Intermittent MIL "ON" DTC P0335

Some 2006 – 2012 model year vehicles equipped with the 2AZ engine may exhibit an intermittent MIL "ON" condition with Diagnostic Trouble Code (DTC) P0335 (Crankshaft Position Sensor "A" Circuit) stored. The intake camshaft gear assembly has been improved to help prevent this condition.

Figure 1.

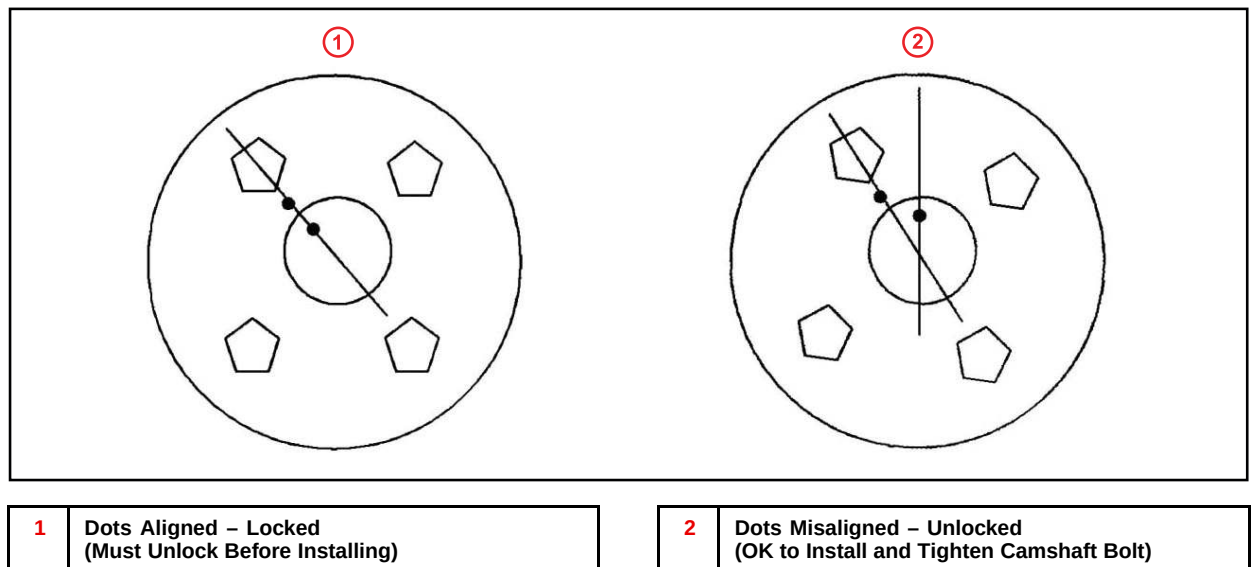
3. Identify whether the camshaft timing gear is unlocked or locked. (See Figure 1).

- If the camshaft timing gear is unlocked, it is ready to install.
- If it is LOCKED, follow the steps below to unlock the camshaft timing gear **before** installing.

Figure 2.

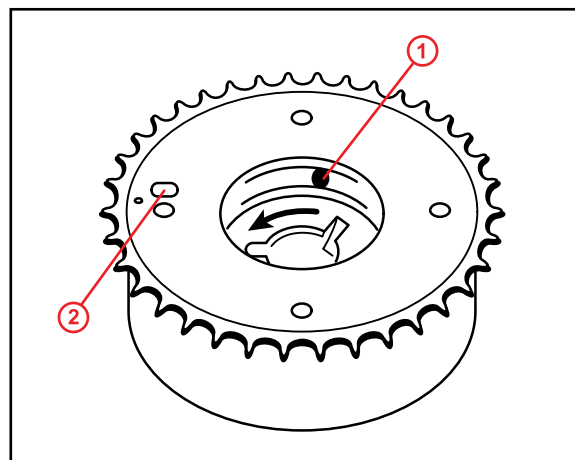
- A. To disengage the camshaft timing gear lock pin, apply and hold approximately 21 psi of air pressure at the oil feed hole located 90 degrees clockwise of the oval slot. (See Figure 2.)

The lock pin is inside the gear, NOT the one located in the oval slot.

- B. With the 21 psi of air still applied to the gear, turn the interior assembly counterclockwise. (See black arrow in Figure 2.)
- C. Install the timing gear assembly onto the camshaft with the straight pin slightly to the right of the key groove as shown in Figure 3.

Figure 4.

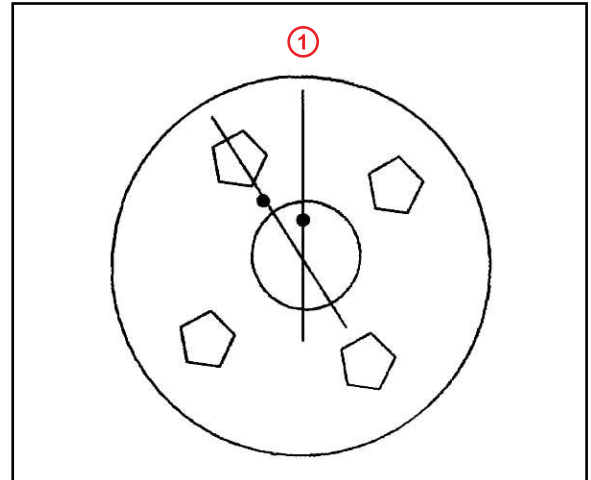
- E. Check that the camshaft timing gear is fully seated on the camshaft and that there is no clearance between the end of the camshaft and the timing gear. Install the camshaft bolt finger tight.

Check to make sure that the camshaft timing gear is still unlocked **BEFORE** tightening the camshaft bolt. The lock pin **MUST** be unlocked to prevent damage to the camshaft timing gear lock pin during tightening.

Dots Misaligned – Unlocked
(OK to Install and Tighten Camshaft Bolt)

Figure 5.

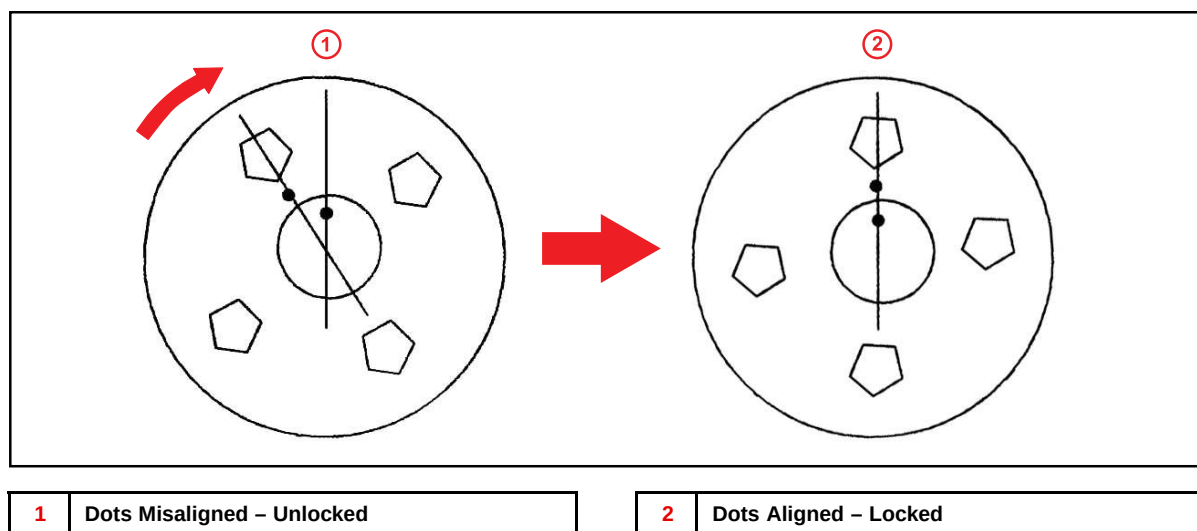
- G. After torquing the camshaft bolt, rotate the camshaft timing gear clockwise while holding the camshaft stationary until the dots are aligned, to engage the camshaft timing gear lock pin.

Camshaft timing is performed with the camshaft timing gear in the locked position (dots aligned).
